**ADDENDUM NUMBER: ONE**

**PROJECT:** Pamlico County EOC / 911 Dispatch  
Bayboro, North Carolina  
Project Number 18068

**DATE:** October 9, 2024

Sheet Title: REFLECTED CEILING PLAN

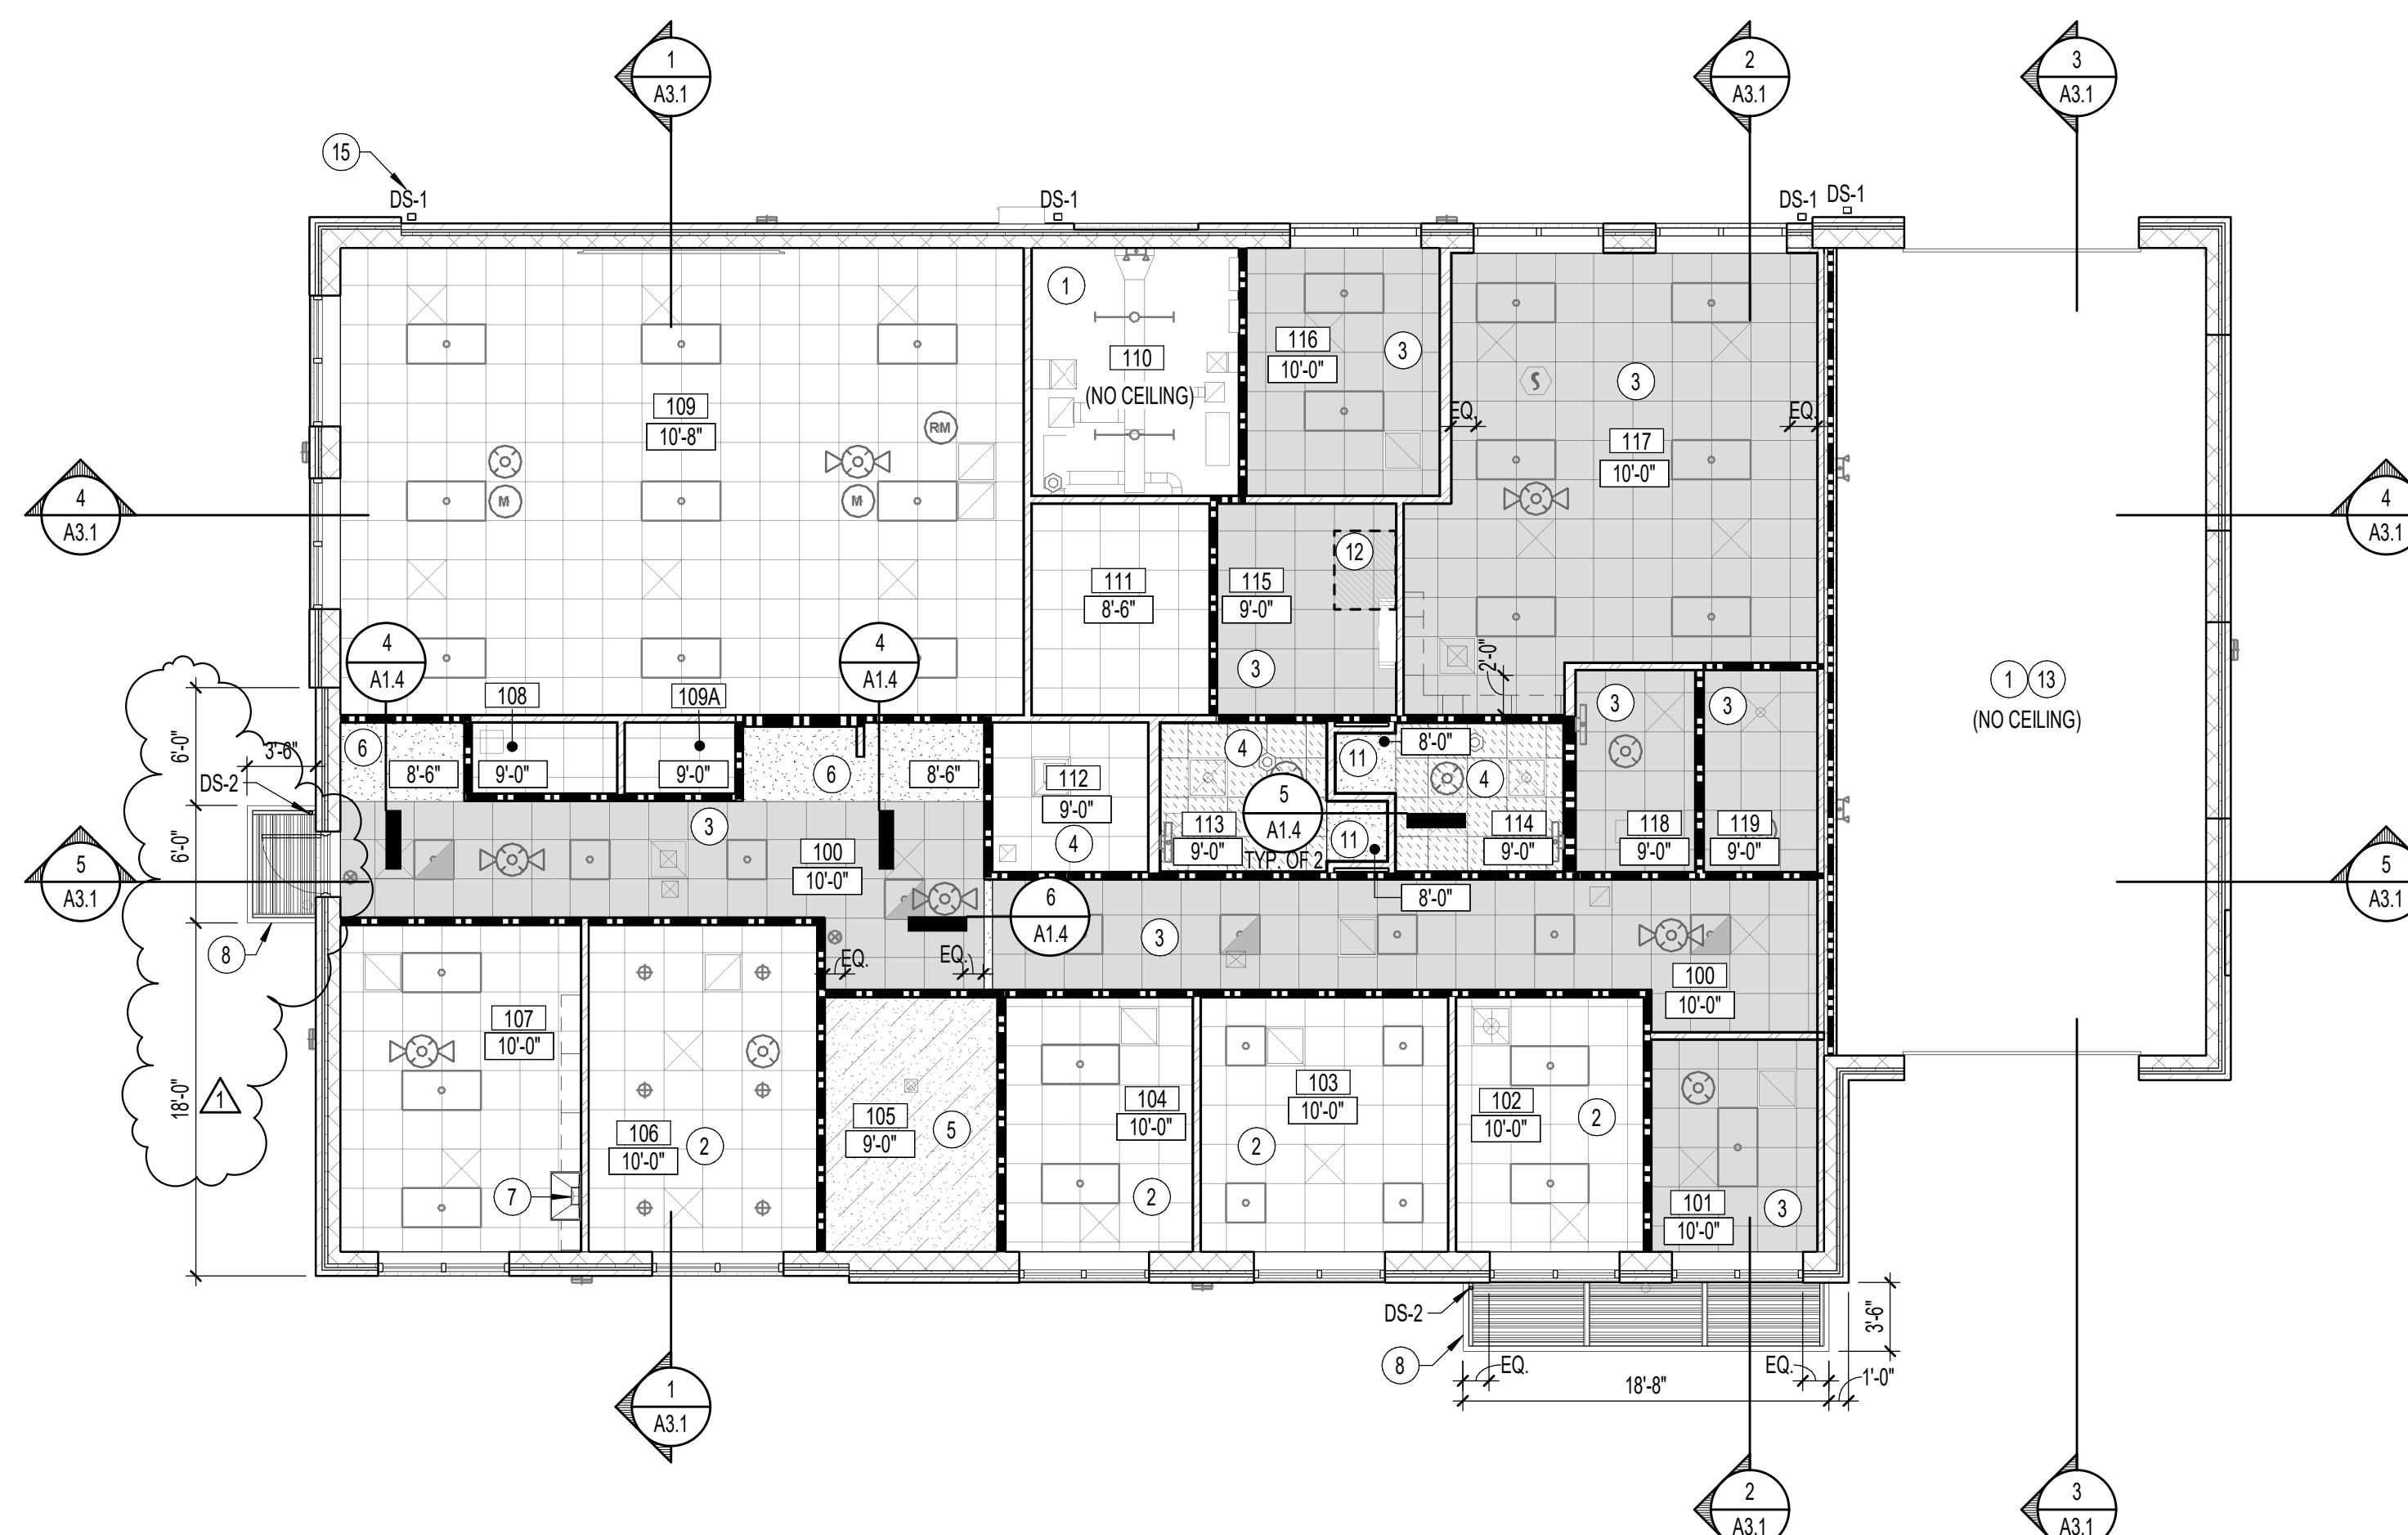
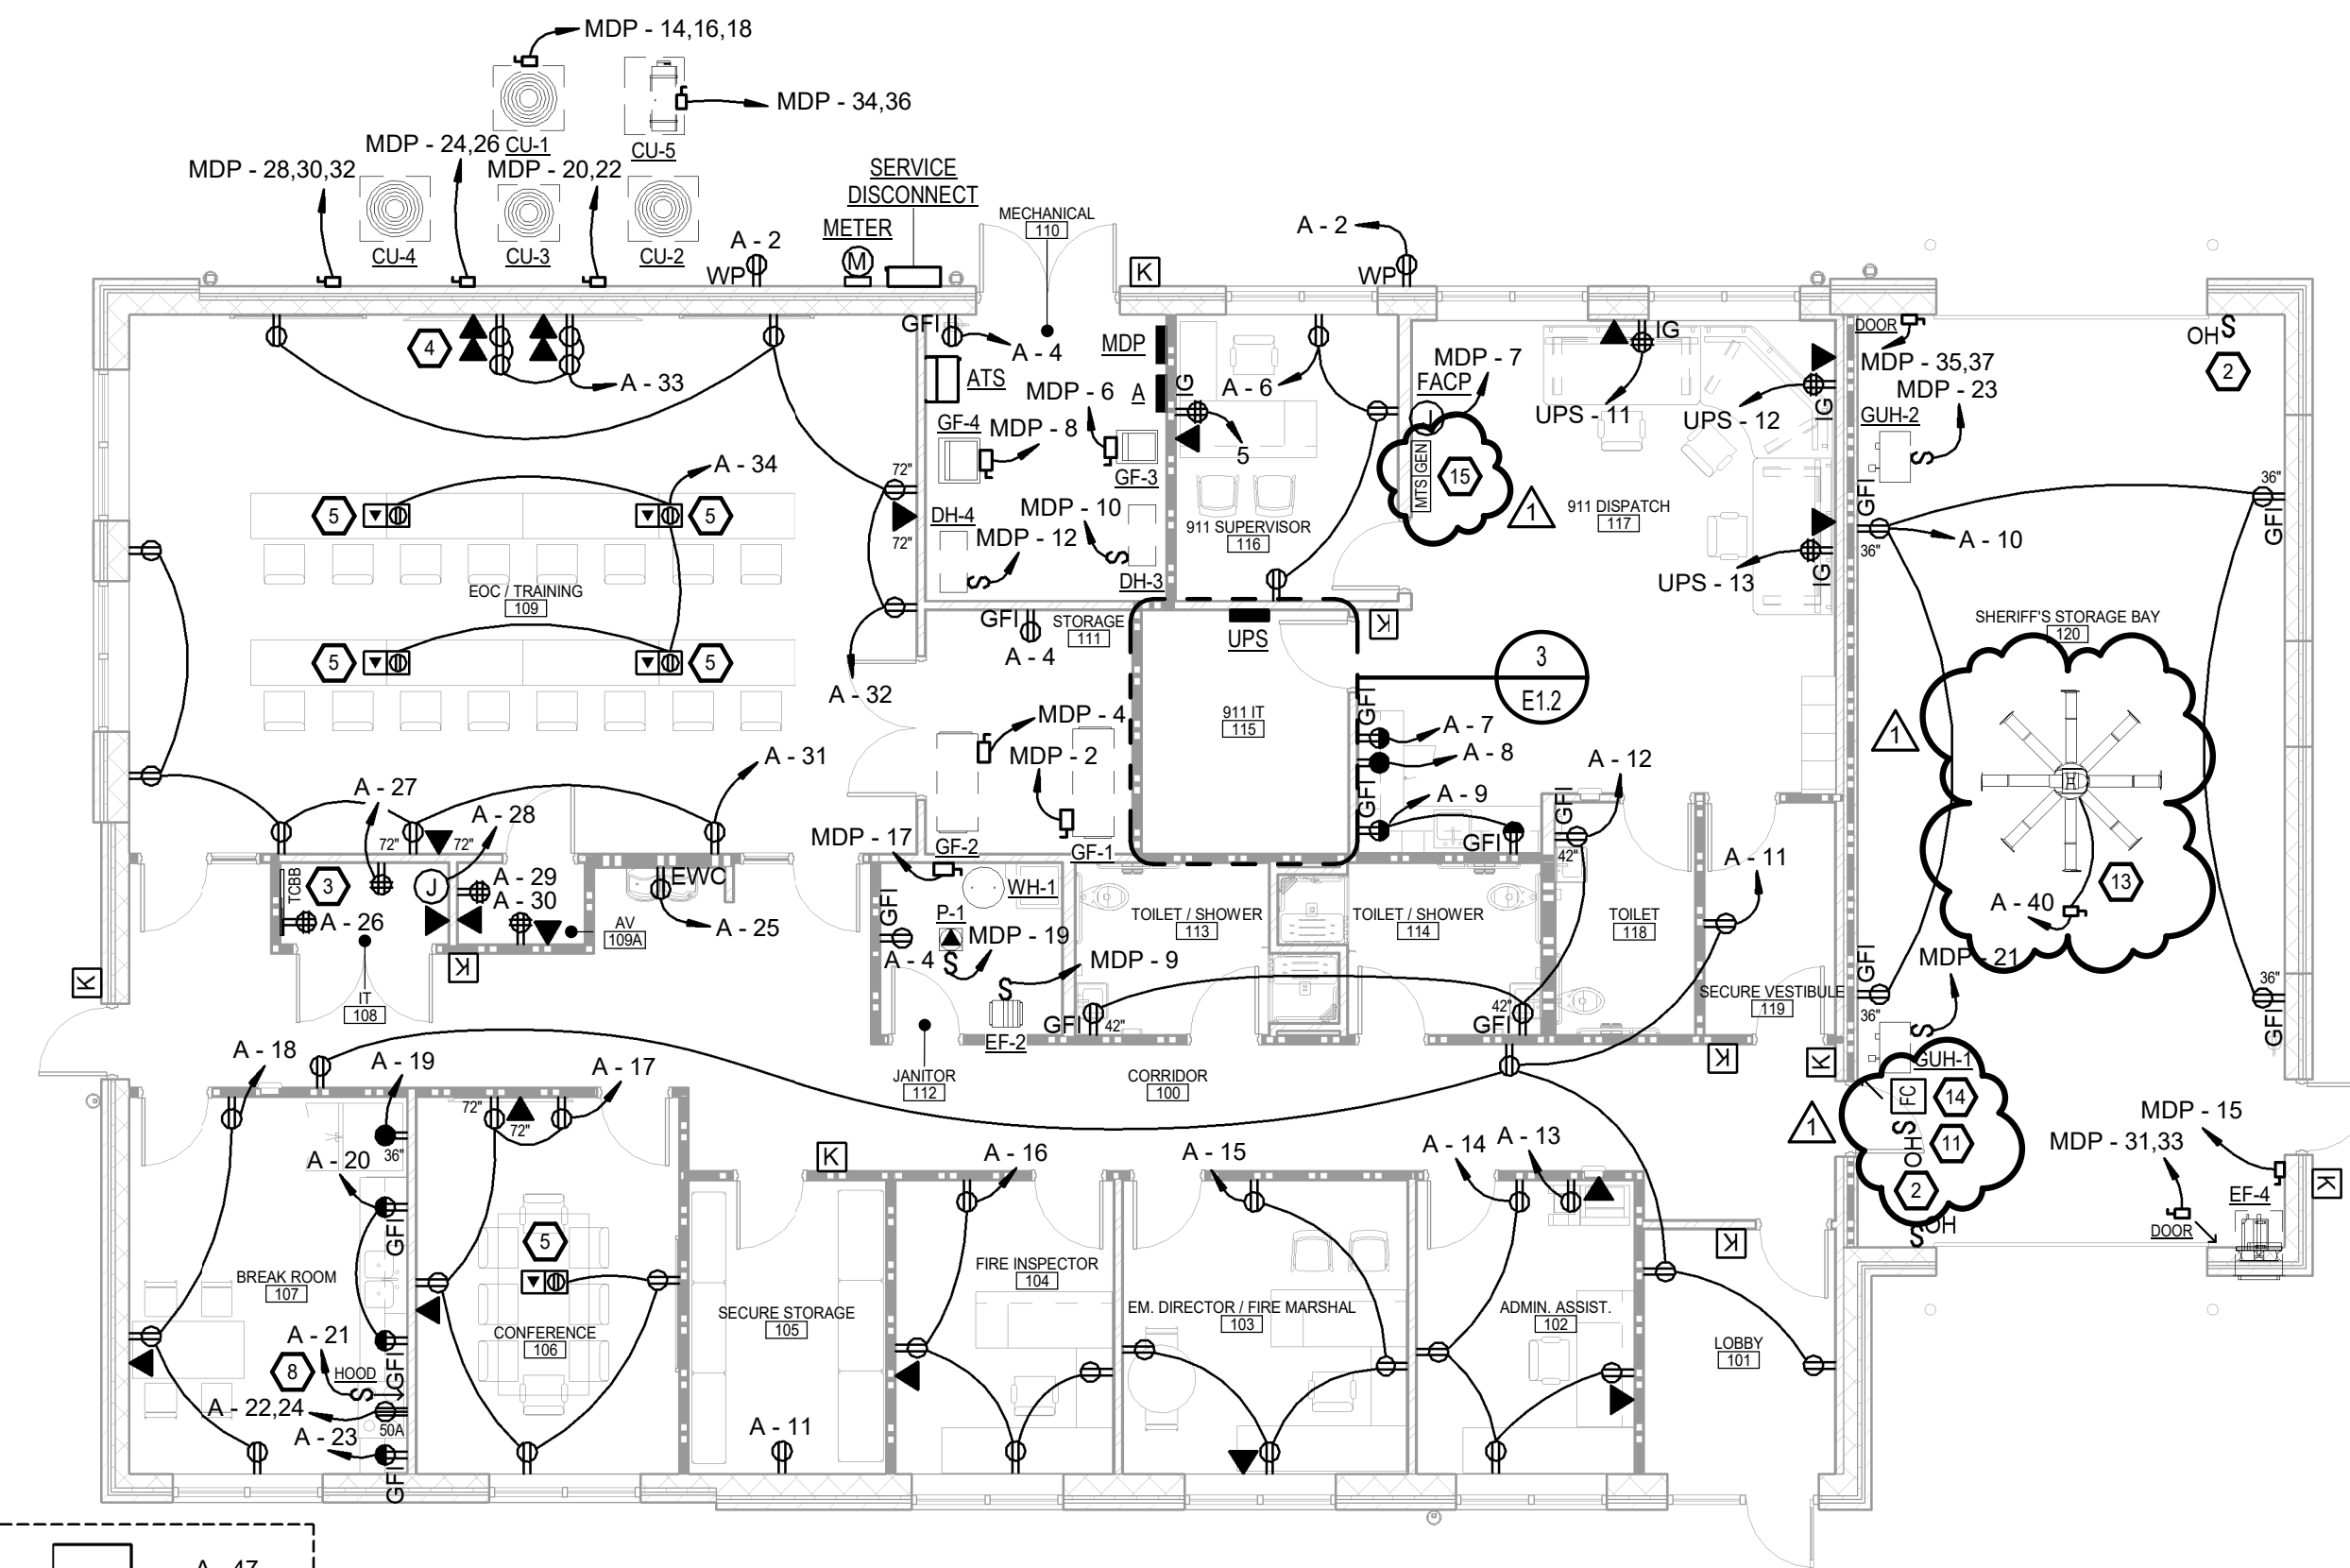
**Item 3 Change:**     **Sheet A1.1 – Floor Plan & Sheet A1.4 – Reflected Ceiling Plan – Door Swing**  
Replace Sheet A1.1 – Floor Plan & Sheet A1.4 – Reflected Ceiling Plan in their entirety. Change swing of door 100A as shown. Door and architectural canopy have been moved 8” to allow for enough clearance at side of door. Move adjacent access control, light switch, and exterior sconce light fixture to latch side of door. Move the downspout for the canopy above to the hinge side of door.

**Item 3 Change:**     **Sheet A1.4 – Reflected Ceiling Plan**  
In the Keynotes – RCP legend, revise keynote #3 to read:

ABOVE LAY-IN CEILING PROVIDE 2 LAYERS OF 5/8” GYPSUM BOARD OVER 1X2 FURRING AT 16” O.C. MAX AT UNDERSIDE OF TRUSSES FOR A 1 HOUR RATING AT ROOM SIDE PER NCSBC TABLE 722.6.2(1).  
CONTRACTOR MAY USE 7/8” METAL HAT CHANNELS AT 16” O.C. IN-LIEU OF 1X2 FURRING.
